DATE MAILED: 06/01/2006

Office Action Summary	Application No. 10/697,554	Applicant(s) JOHNSON ET AL.	
	Examiner Phong H. Nguyen	Art Unit 3724

DETAILED ACTION

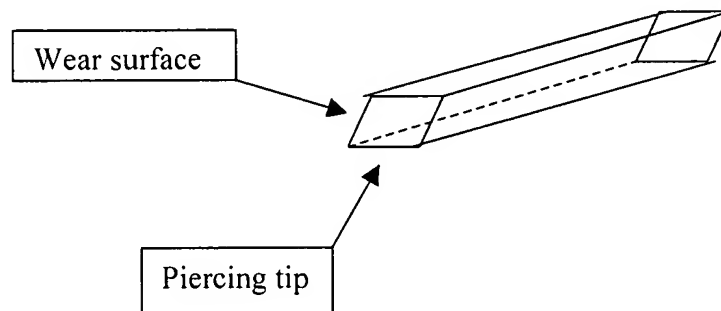
4. Claims 1-11, 14-20 and 50-55 are rejected under 35 U.S.C. 103(a) as being unpatentable over Morikawa (5,339,525) in view of Sederberg.

Regarding claims 1-3, 50 and 51, Morikawa teaches a wearing plate/piercing tip

7. See Figs. 1-5 and the below sketch.

Morikawa fails to teach the geometric configuration of the wear plate/pierce tip being the same in a first position and a second position, wherein the second position is a position in which the wear plate/tip insert is rotated 180 degrees. Sederberg teaches the geometric configuration of the wear plate/pierce tip 116 being the same in the first position and the second position. See Fig. 13 and 14. Therefore, it would have been obvious to one skilled in the art to provide the wear plate/pierce tip of Morikawa the

geometric configuration as taught in Sederberg so that both sides of the wear plate/pierce tip can be used to reduce the spare part of the wear plate/pierce tip.

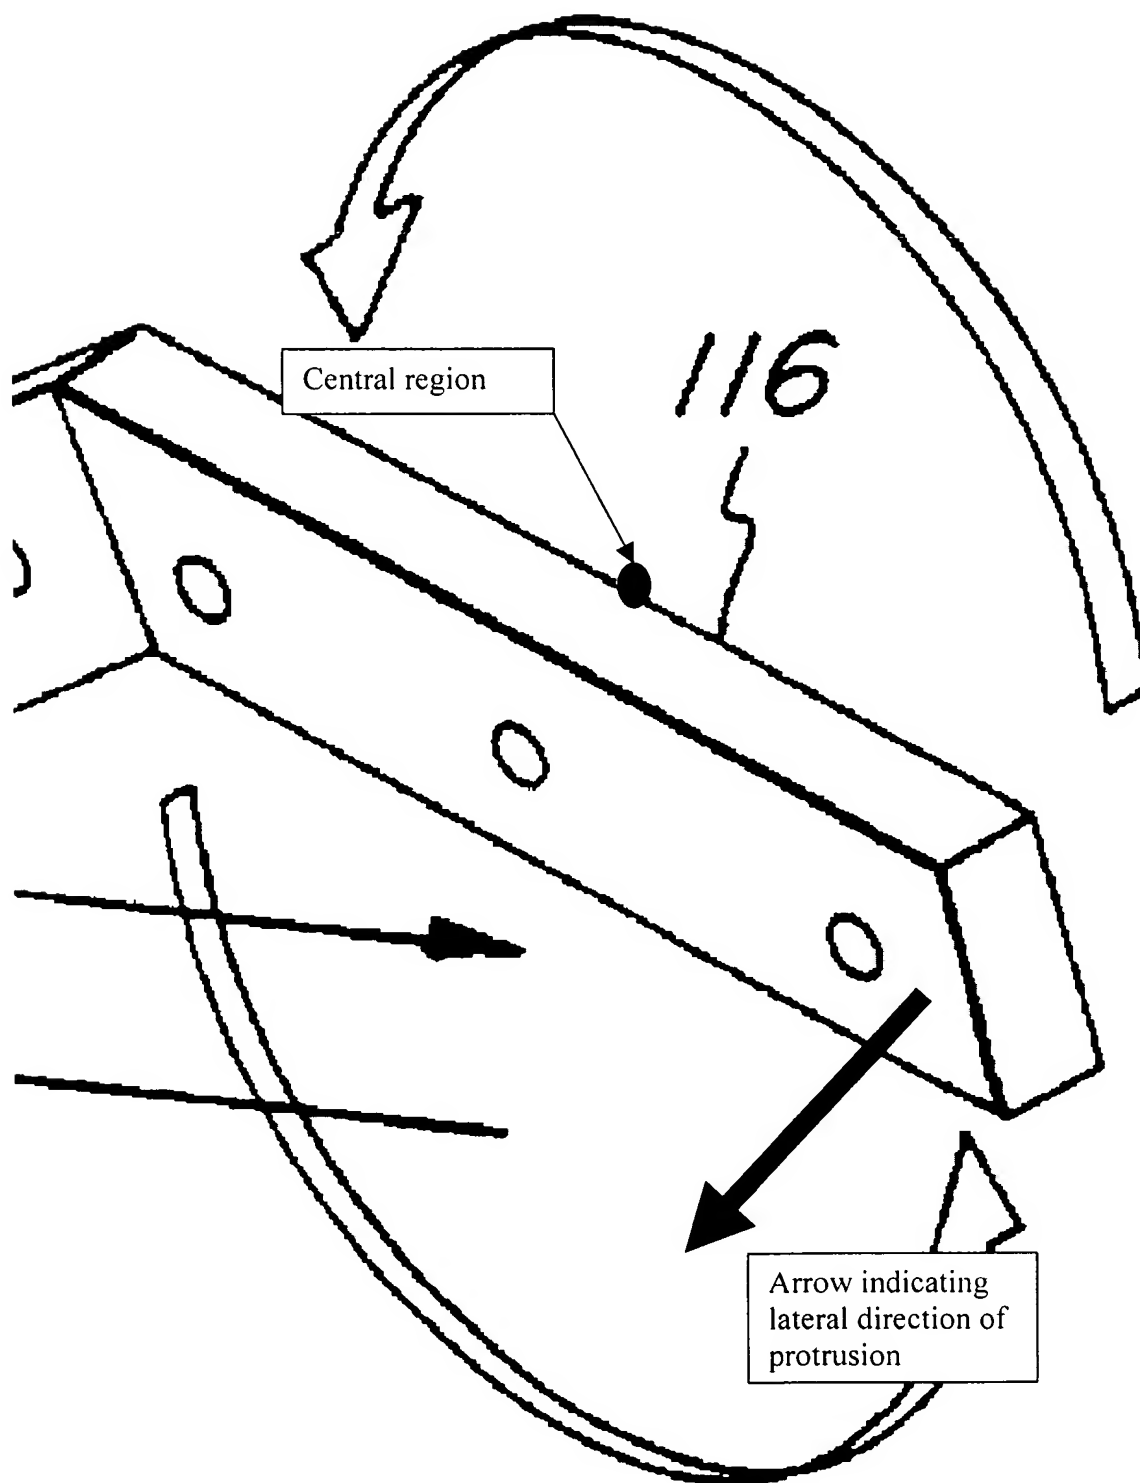
Applicant misinterprets the Examiner's interpretation of Sederberg. Sederberg clearly teaches the cutting tips protruding laterally with respect to a central region of the cutting blade as shown below.
